ADDENDUM NO. 2

CONTRACT NO. 22-522

**Domestic Water System Improvements
Westchester County Airport
Town of Harrison, North Castle and Village of Rye Brook, New York**

SHEET
NUMBER
C-29

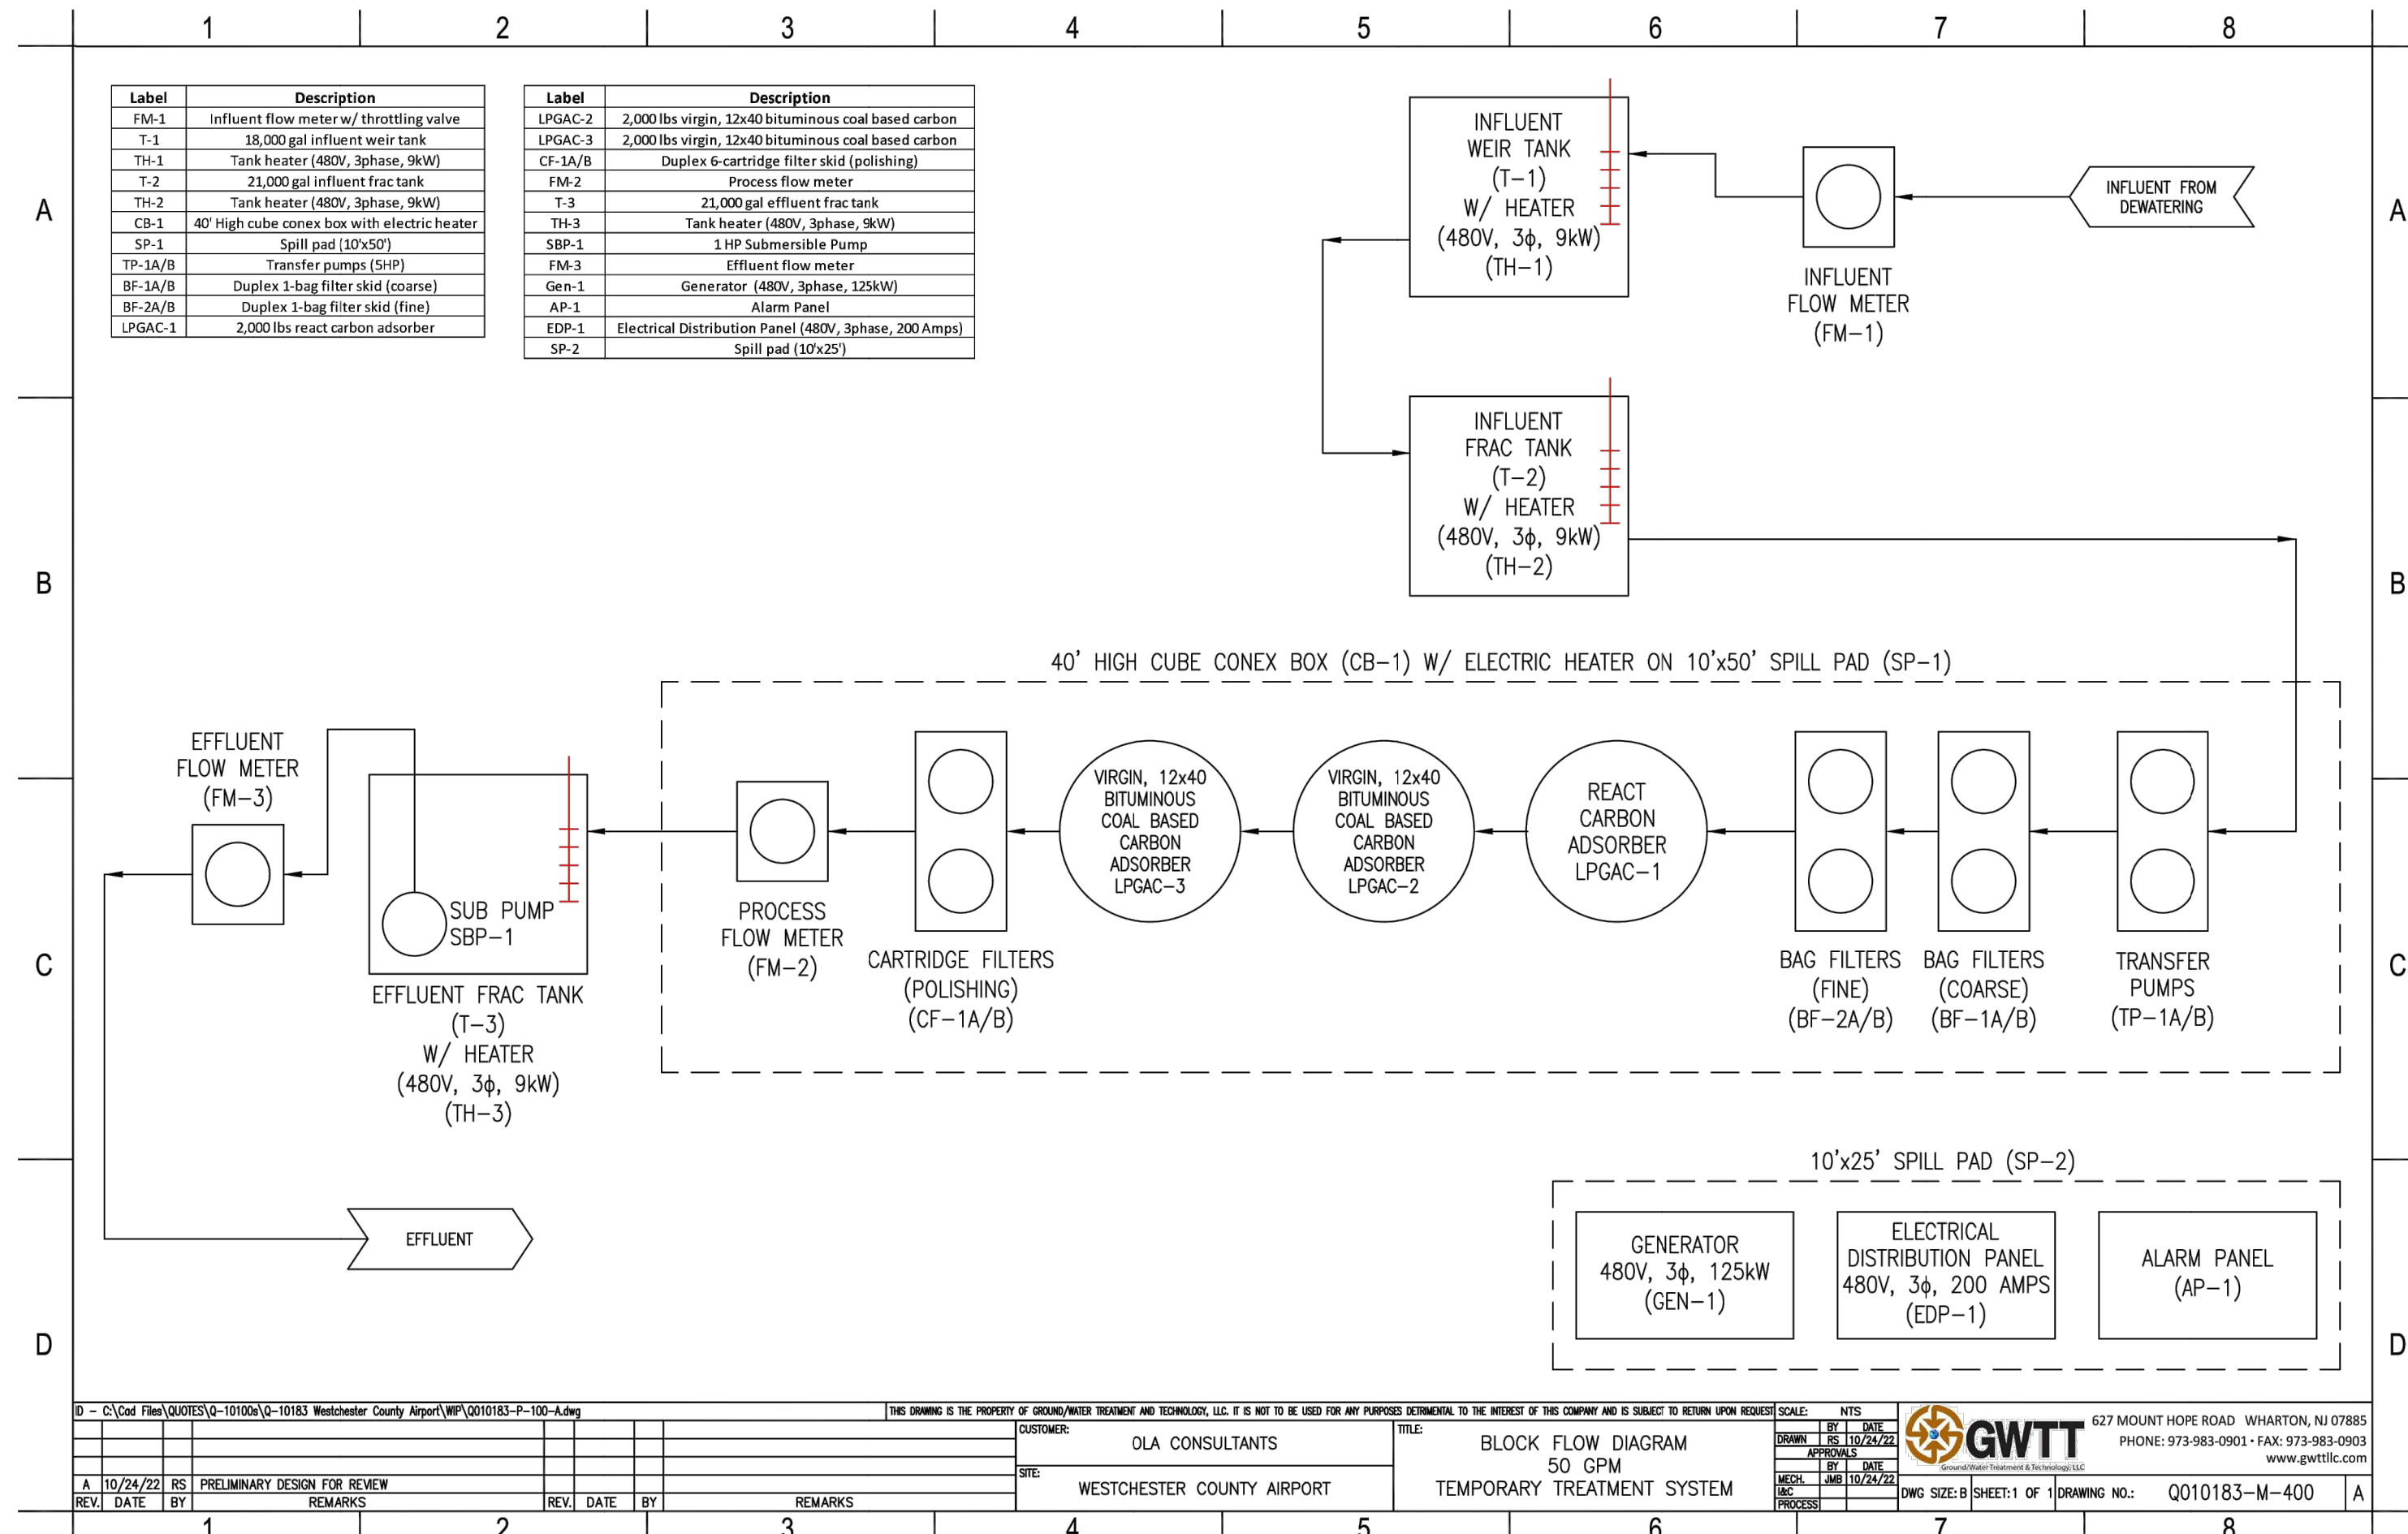
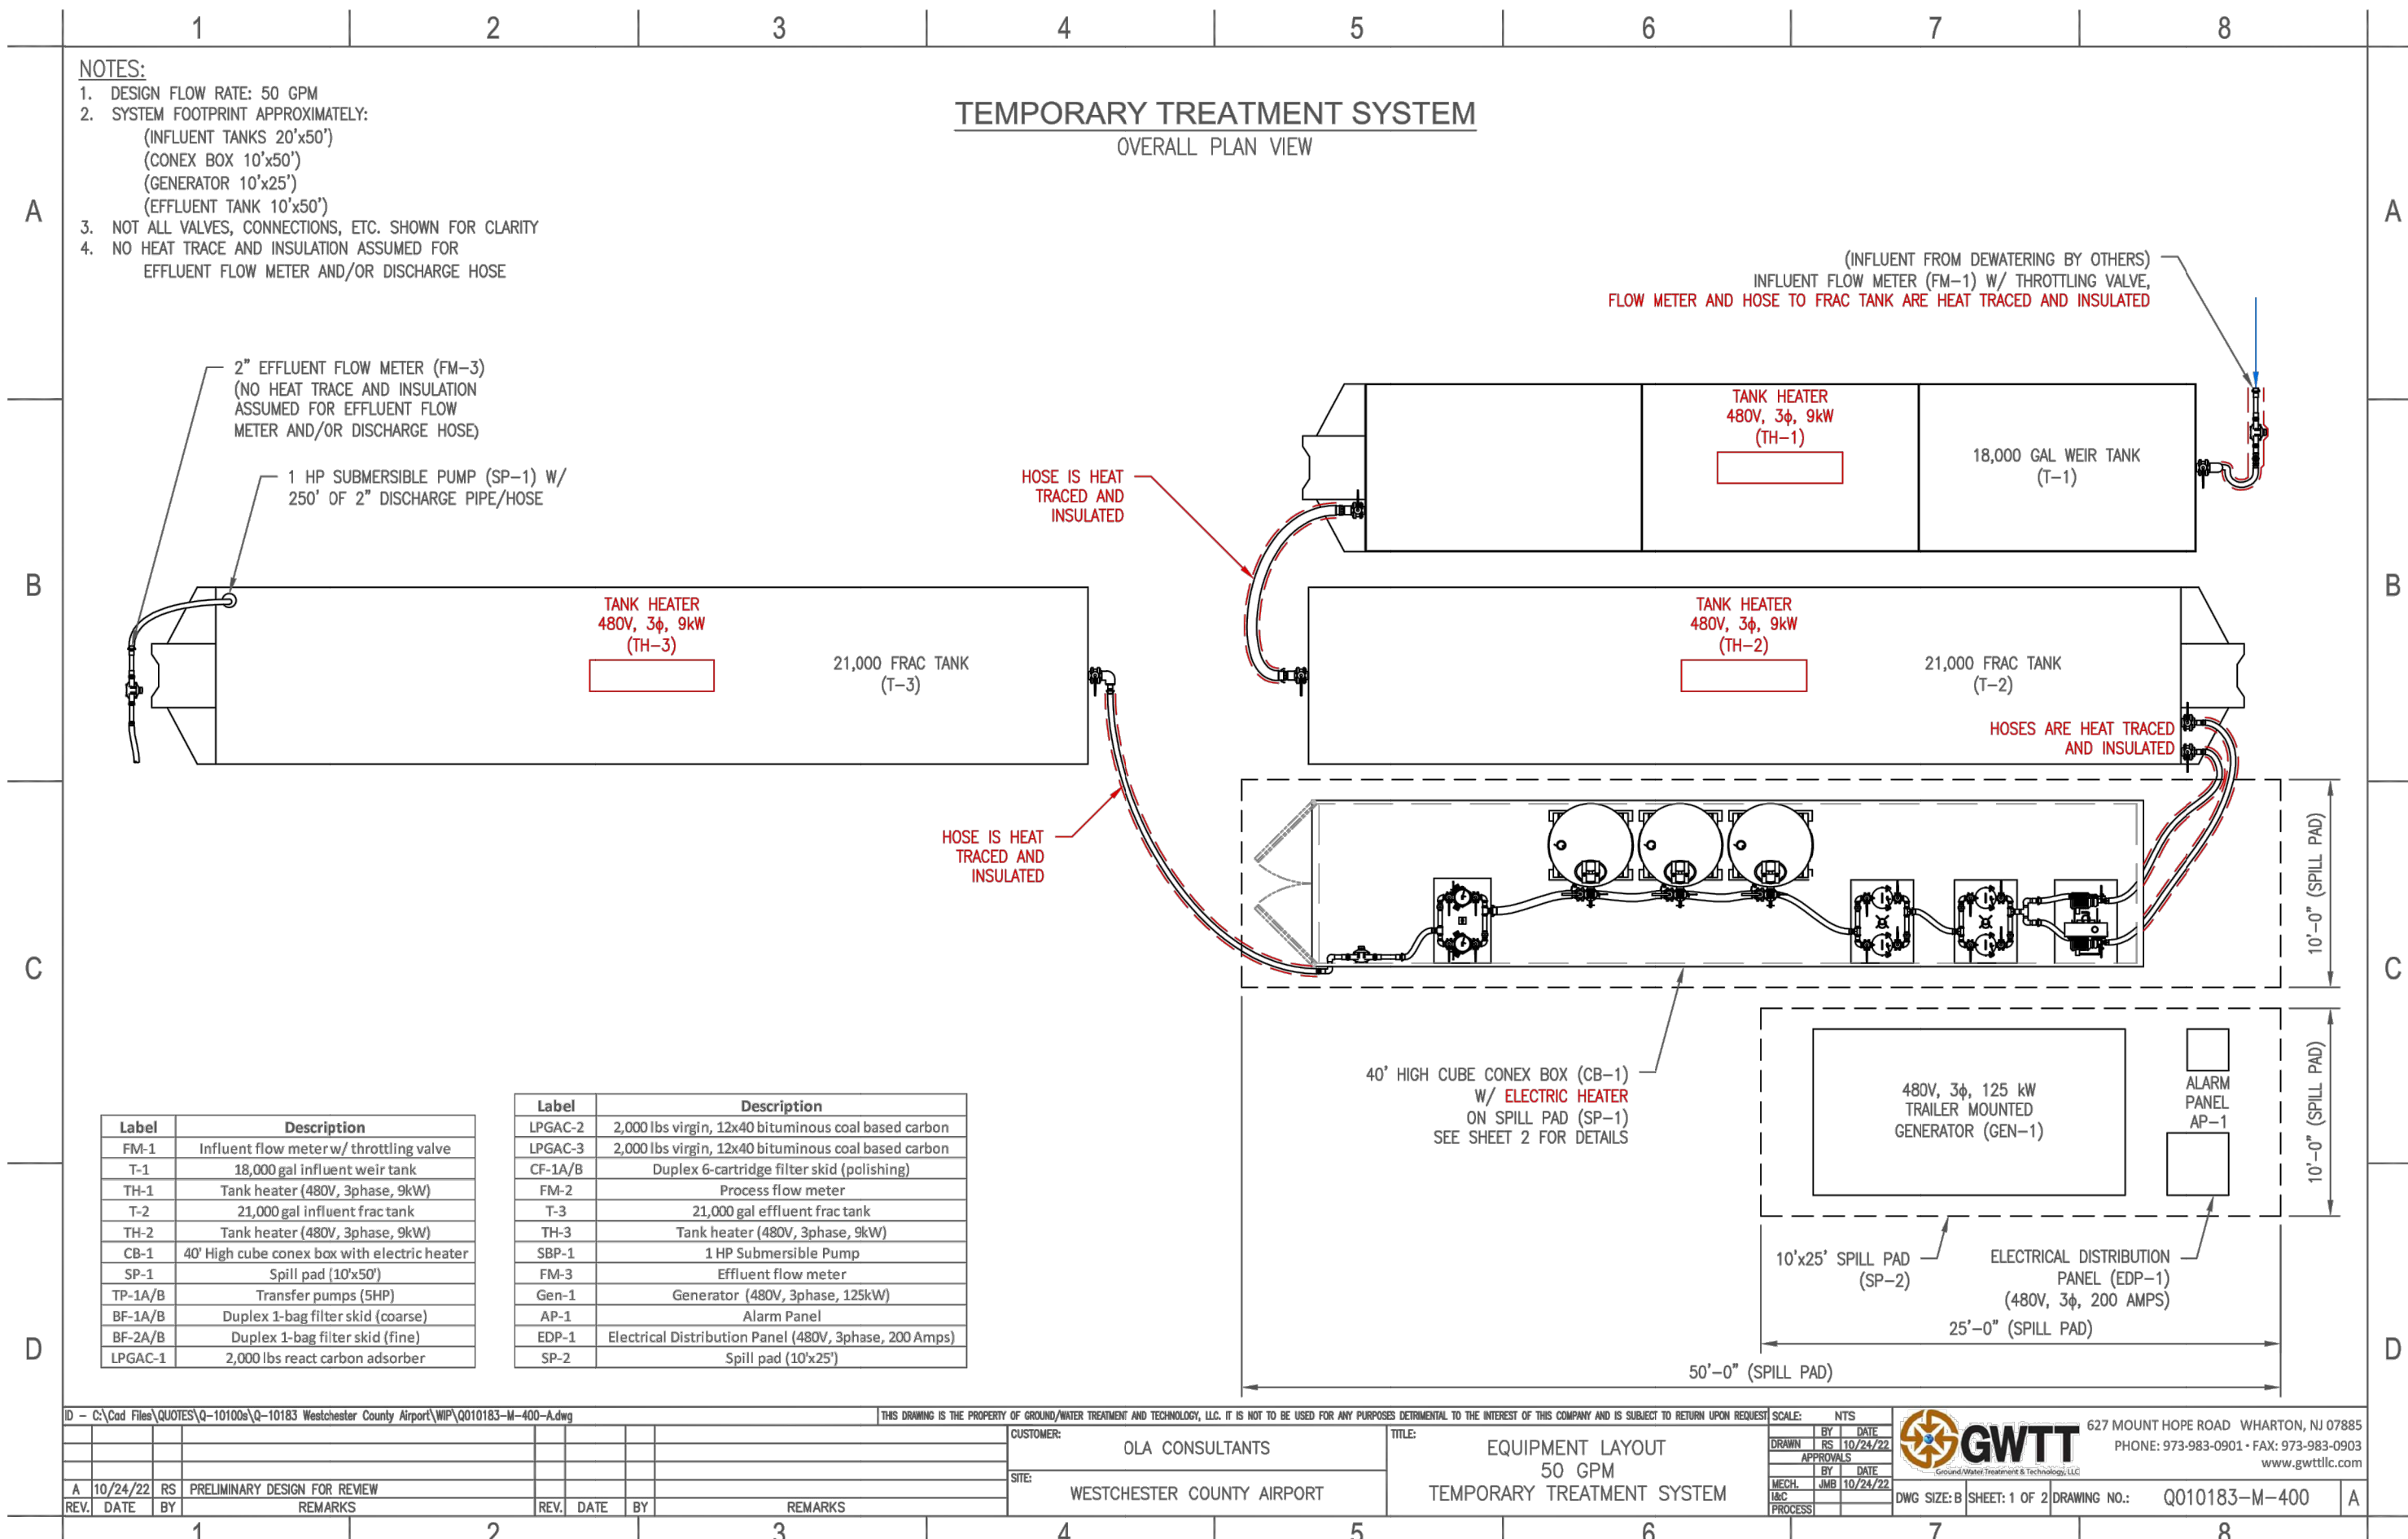
Item 4: Drawing C-29 shall be deleted and the revised drawing C-29 is attached hereto.

28	The technical spec appears to general in nature and not specific for this project. With regards to the buildings, please specify if coatings are required for: CMU block (interior and exterior), concrete slab, interior piping coating (paint & color). Also, are identification signs or tags needed?	<p>No interior or exterior coating of CMU is required. Interior concrete slab coating will be as specified in Section 03 30 00, paragraph 3.8.</p> <p>Aboveground plumbing piping shall be insulated per spec section 22 07 19 and labeled/identified per spec section 22 05 52. Piping is not required to be painted.</p>
29	Owners Protective Liability Policy naming the County as insured, with a minimum limit of liability per occurrence of \$3,000,000 (where applicable, or as determined by the Director, Risk Management - is an Owners Protective Liab policy required?	This policy is required.
30	Please confirm whether transportation of pumped groundwater from work area to proposed treatment area is included in pricing for item no. GG (groundwater treatment and disposal)	Refer to the notes on revised drawing C-29 included herein.

- GROUND WATER FROM DEWATERING OPERATIONS IS NOT PERMITTED TO BE DISCHARGED TO THE GROUND SURFACE, DRAINAGE DITCH, SURFACE WATER BODY, STREAM, WETLAND, STORM DRAIN OR SANITARY SEWER.

- THE CONTRACTOR SHALL FURNISH, INSTALL AND OPERATE A GROUNDWATER TREATMENT SYSTEM THAT WILL BE USED TO TREAT GROUNDWATER THAT IS REMOVED FROM THE GROUND BY DEWATERING FOR THE PURPOSE OF REMOVING PER- AND POLYFLUOROALKYL SUBSTANCES (PFAS). REFER TO BLOCK DIAGRAM AND EQUIPMENT LAYOUT PREPARED BY GROUND WATER TREATMENT & TECHNOLOGY, LLC (GWTT).

- ALL GROUNDWATER REMOVED FROM EXCAVATIONS, PITS AND WORK AREAS, MUST BE TRANSPORTED TO THE DESIGNATED TREATMENT AREA. FINAL LOCATION AND LAYOUT OF TEMPORARY TREATMENT SYSTEM SHALL BE CONFIRMED AND REVIEWED BY AIRPORT OPERATIONS AND ENGINEER PRIOR TO INSTALLATION.

- ONCE WATER HAS BEEN TREATED THE MAXIMUM RATE OF DISCHARGE FROM THE TREATMENT SYSTEM INTO THE SANITARY SEWER SYSTEM, WILL BE LIMITED TO 17 GALLONS PER MINUTE (GPM) IN ACCORDANCE WITH DEF PERMIT. THE CONTRACTOR SHALL PROVIDE A FLOW CONTROL VALVE, CONTROLLED FLOW ORIFICE DEVICE OR OTHER APPROVED MEANS TO ENSURE DISCHARGE DOES NOT EXCEED 17 GPM. THE CONTRACTOR SHALL BE RESPONSIBLE TO RECORD EFFLUENT FLOW METER DATA AND SUBMIT TO THE ENGINEER AND OWNER'S REPRESENTATIVE FOR RECORD TO ENSURE DISCHARGE RATE IS NOT EXCEEDED.

- THE CONTRACTOR SHALL SUBMIT A SEQUENCE OF OPERATION OF THE TREATMENT SYSTEM TO THE ENGINEER FOR REVIEW. THE SEQUENCE OF OPERATION SHALL BE SIMILAR TO THE FOLLOWING:

- THE INFLUENT WEIR TANK SHALL BE PROVIDED WITH CONSTANT TANK VOLUME MONITORING AND LEVEL CONTROLS AS A MINIMUM: LOW WATER ALARM, HIGH WATER ALARM
 - THE INFLUENT FRAC TANK SHALL BE PROVIDED WITH CONSTANT TANK VOLUME MONITORING AND LEVEL CONTROLS AS A MINIMUM: LOW WATER ALARM, HIGH WATER ALARM, TRANSFER PUMPS ON/OFF.

- IN THE EVENT THAT THE FRAC TANK WATER SUPPLY REACHES "TRANSFER PUMP ON" LEVEL, THE PUMP(S) SHALL BE ENERGIZED AND SHALL RUN CONTINUOUSLY THROUGH THE TREATMENT SYSTEM UNTIL THE "TRANSFER PUMPS OFF" LEVEL IS REACHED. AUTOMATIC VALVES AT THE INLET/OUTLET OF THE TANK SHALL OPEN/CLOSE AS REQUIRED.

- THE EFFLUENT TANK SHALL BE PROVIDED WITH CONSTANT TANK VOLUME MONITORING AND FIELD ADJUSTABLE LEVEL CONTROLS AS A MINIMUM: LOW WATER ALARM, HIGH WATER ALARM, 25% FULL, 50% FULL, 80% FULL

- IN THE EVENT THAT THE EFFLUENT FRAC TANK REACHES 80% FULL THE TRANSFER PUMPS SHALL BE DE-ENERGIZED AND THE EFFLUENT DISCHARGED AT 17 GPM MAXIMUM. THE CONTRACTOR SHALL DETERMINE THE FREQUENCY OF EFFLUENT DISCHARGE BASED ON DEWATERING FIELD CONDITIONS.

- ALL TANKS SHALL BE PROVIDED WITH EXTERIOR AUDIBLE ALARMS.
